MAYOR & COUNCIL COMMUNICATION

AGENDA ITEM: Phase 1 Downtown Street, Drainage, and Utility Improvements – Approve Revised Alley Plan.

LAKE ELMO OLD VILLAGE
ALLEY OPTION 2
REDUCED WIDTH PED CROSSING

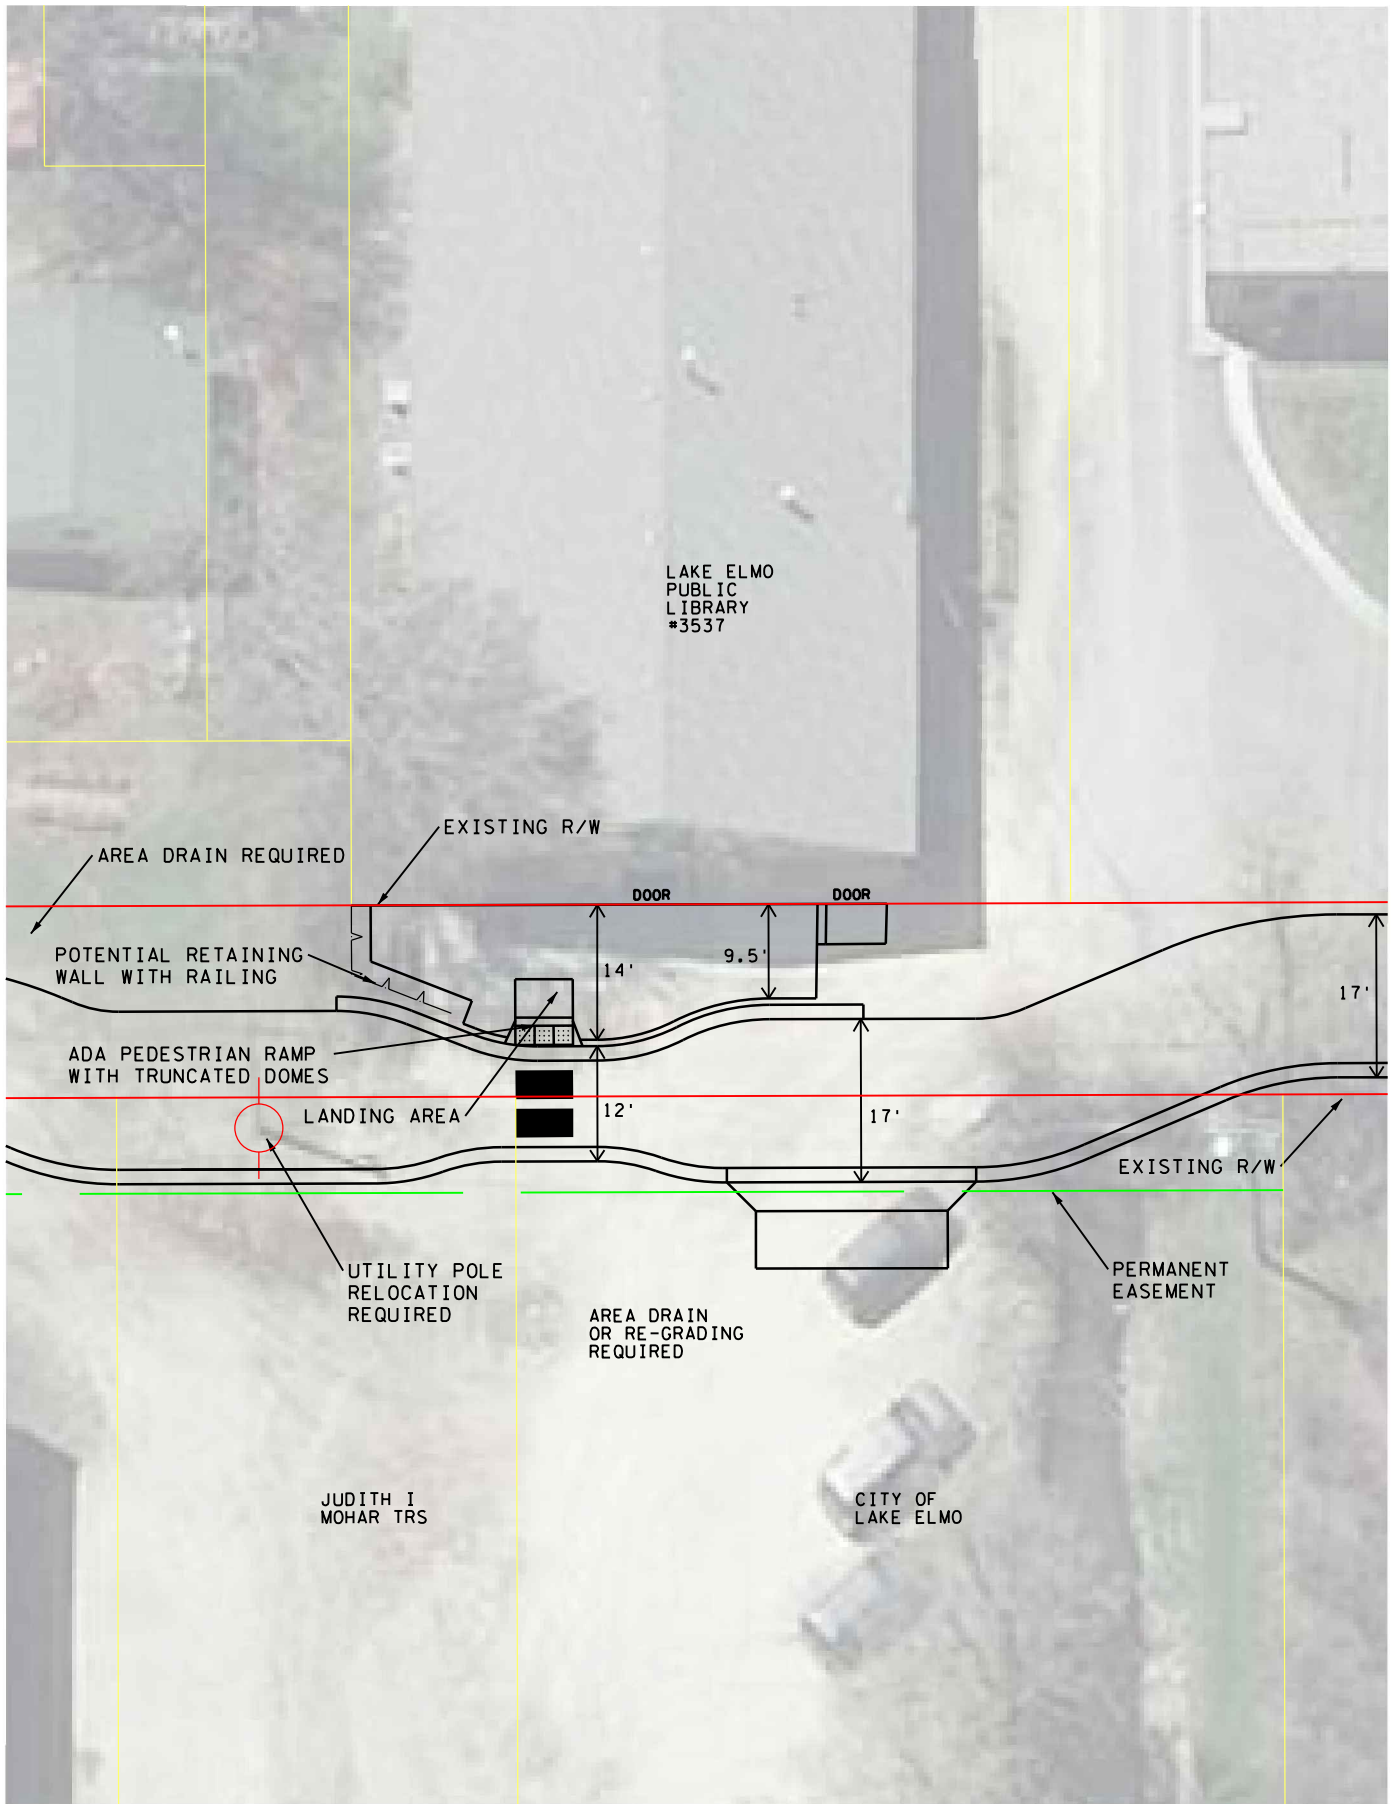
The Phase 1 Downtown Street, Drainage, and Utility Improvements project is currently in construction which includes extension of sanitary sewer and the reconstruction of the alley between Upper 33th Street and 36th Street. Alterations to the geometric layout for the alley were requested by the library board. Several meetings and layout options were prepared to address this request resulting in the proposed Option 2 Reduced Width Pedestrian Crossing. The alley is realigned to provide additional separation from the alley centerline to the rear of the library building, the alley centerline profile has been adjusted to lessen the vertical grade separation between the alley and the library first floor elevation, and a reduced width pedestrian crossing has been added to facilitate pedestrian movements between the library rear door and parking lot area.
